ADDENDUM NO. 2

September 11, 2026

PORTAGE HIGH SCHOOL: 2026 RENOVATIONS PROJECT

Project No. 226023.00

MD11B

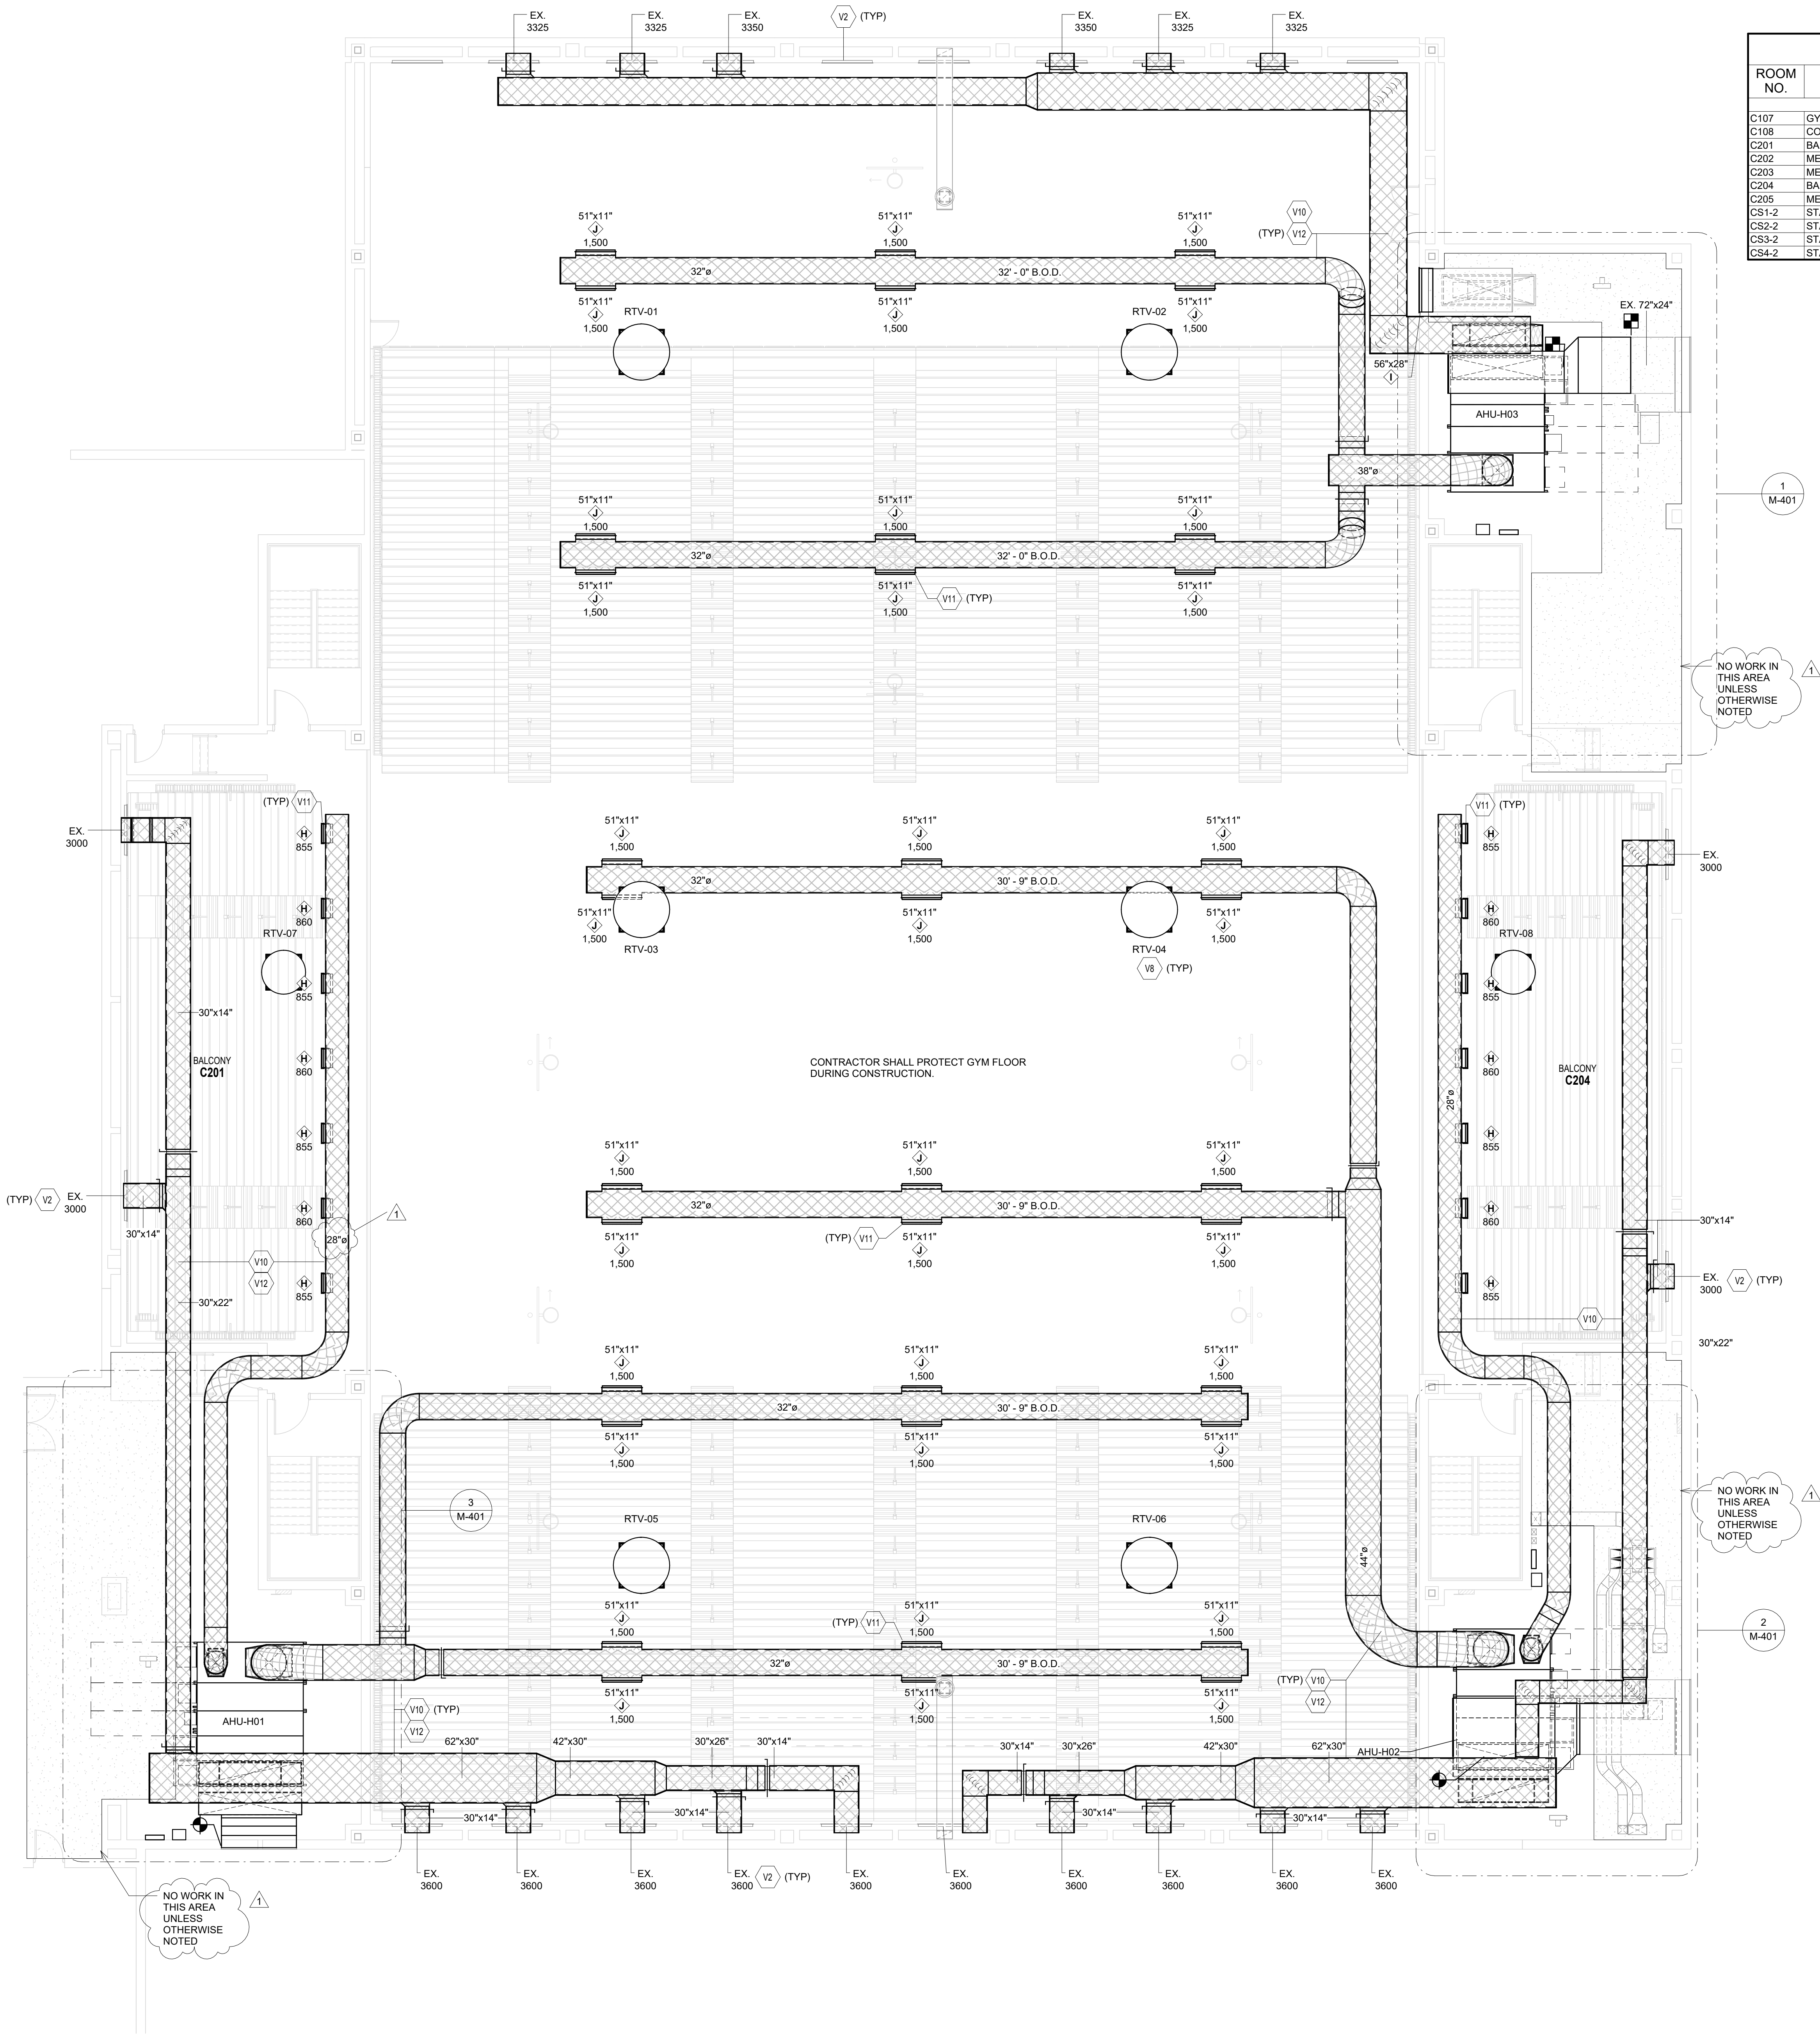
The **Bid Category No. 2 Contractor** is responsible to provide all work associated with masonry demolition, infill, and lintels required for ductwork/mechanical openings in the gymnasium, as shown on the mechanical drawings. Coordinate opening sizes and locations with the mechanical contractor.

EP11B

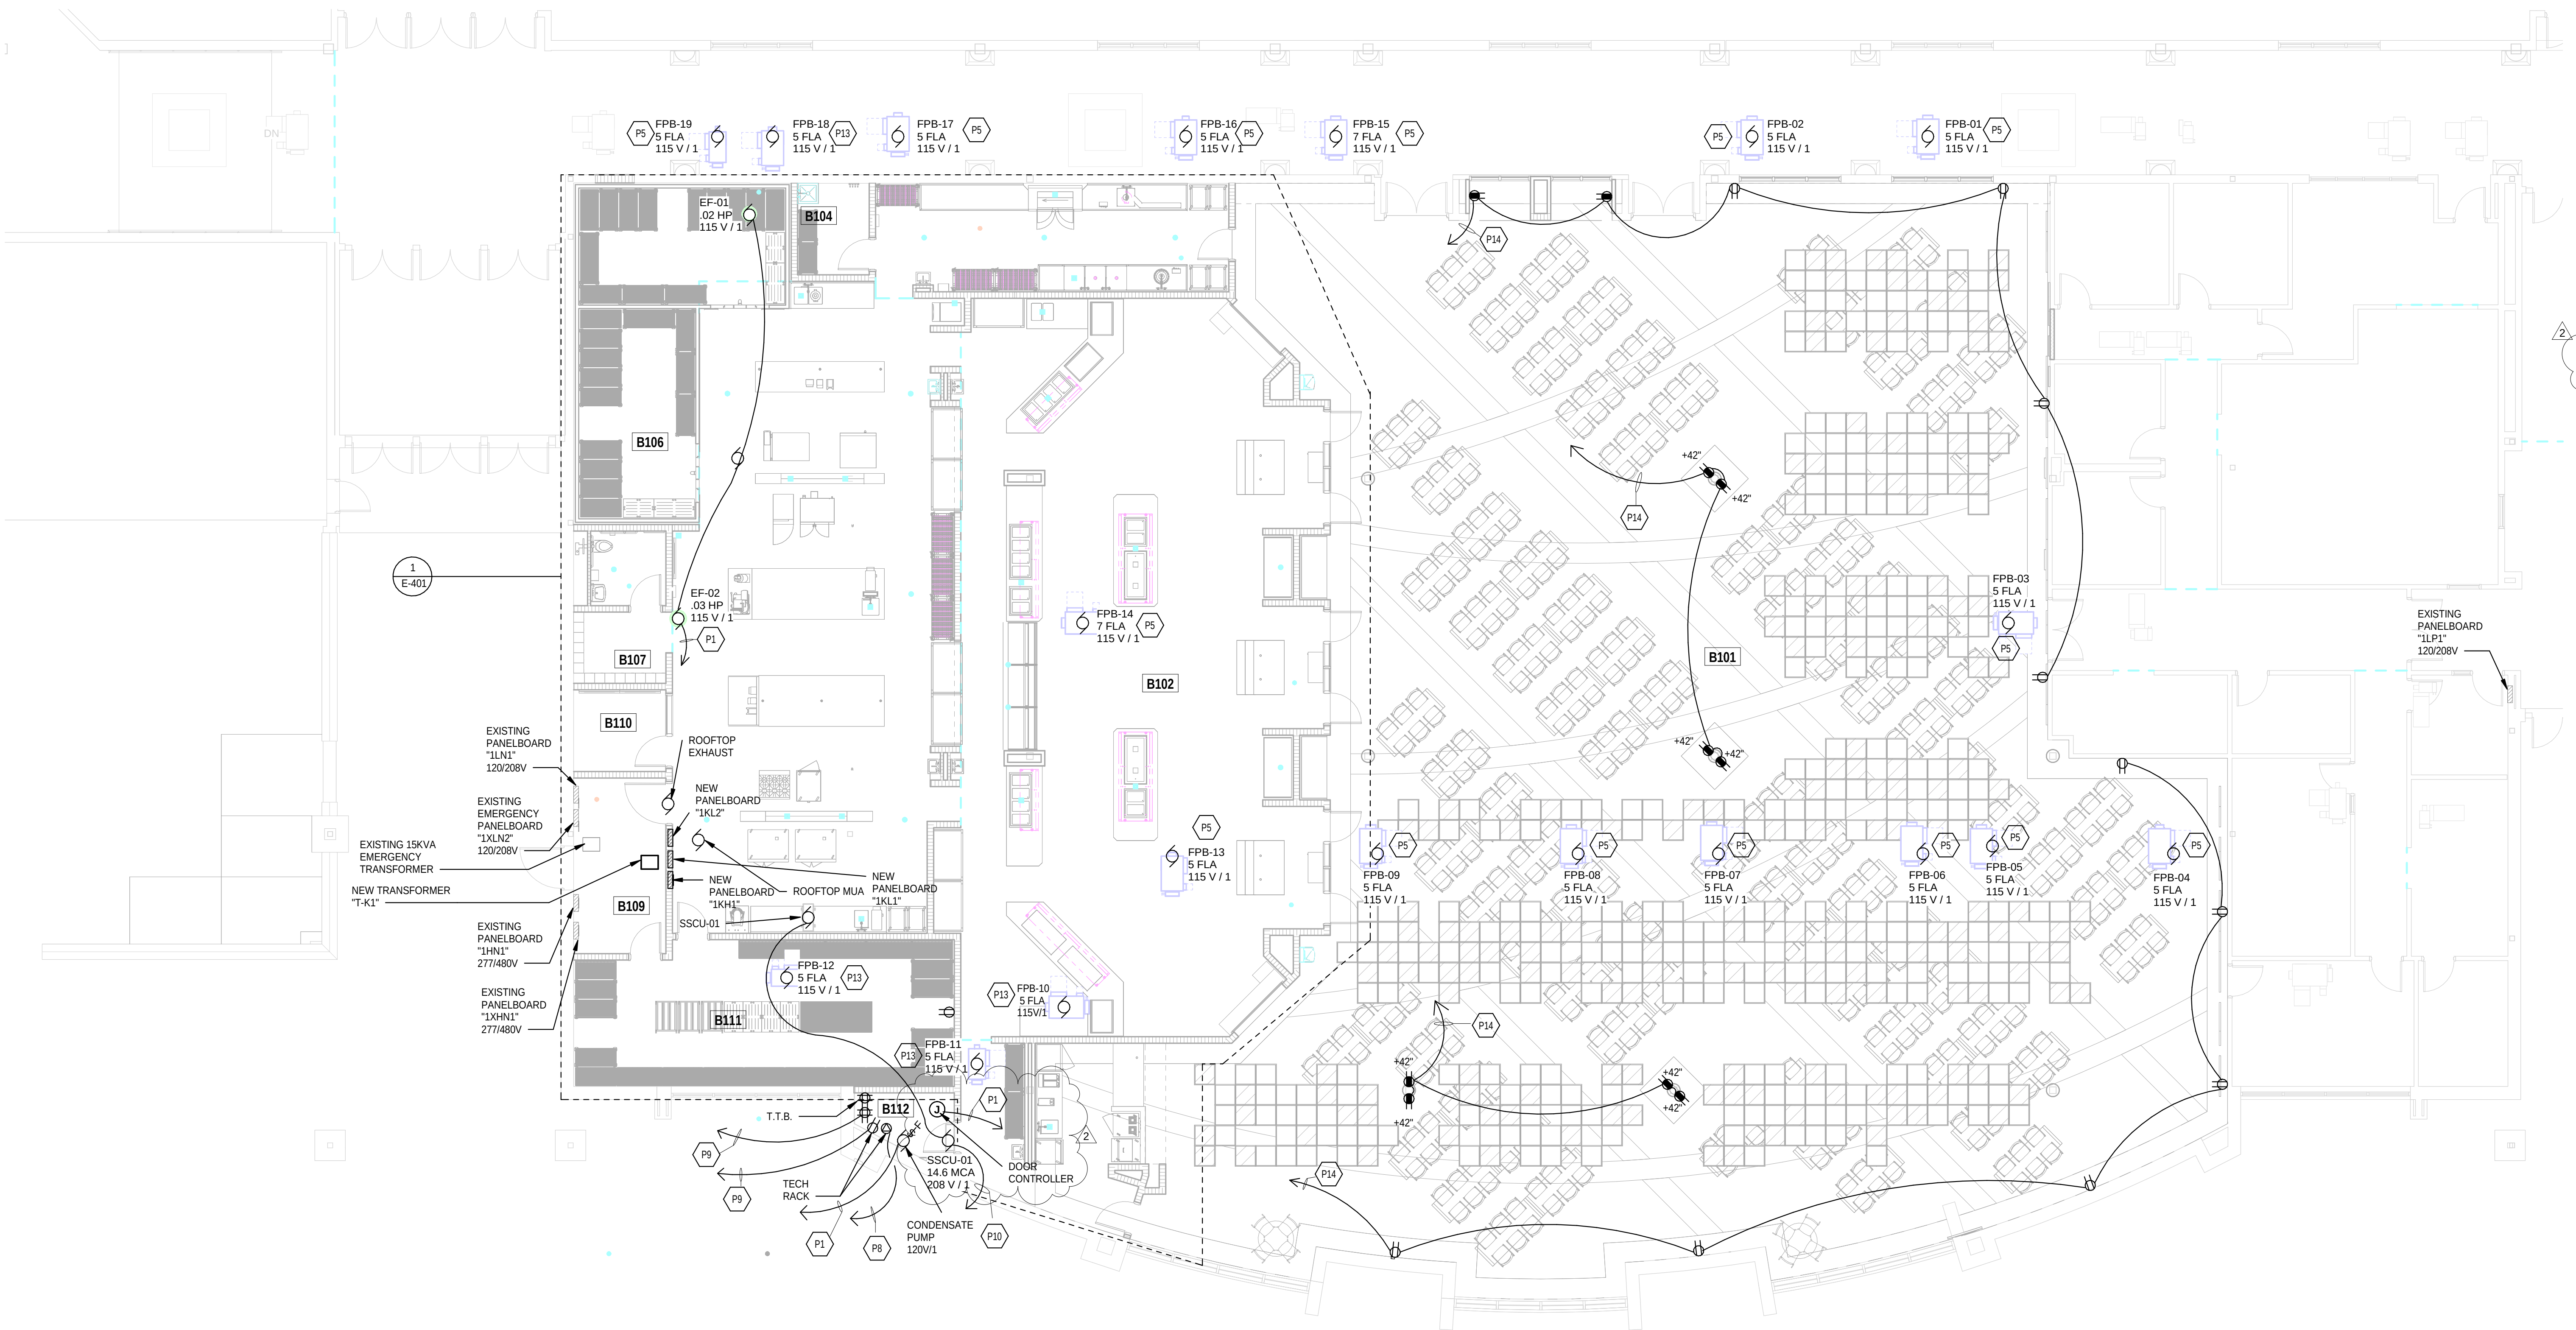
Drawing Sheets: AD-11A, AD-11B, AD-12C, A-11B, A-12C, AC-11B, I-11B, I-601, MD11B, MV12C, ET11C, E-11A, EP11B, E-601, TD101, TD102, and T-11C have been revised, dated 9/10/26, and is included with and hereby made a part of this Addendum. These Drawings supersede the original documents.
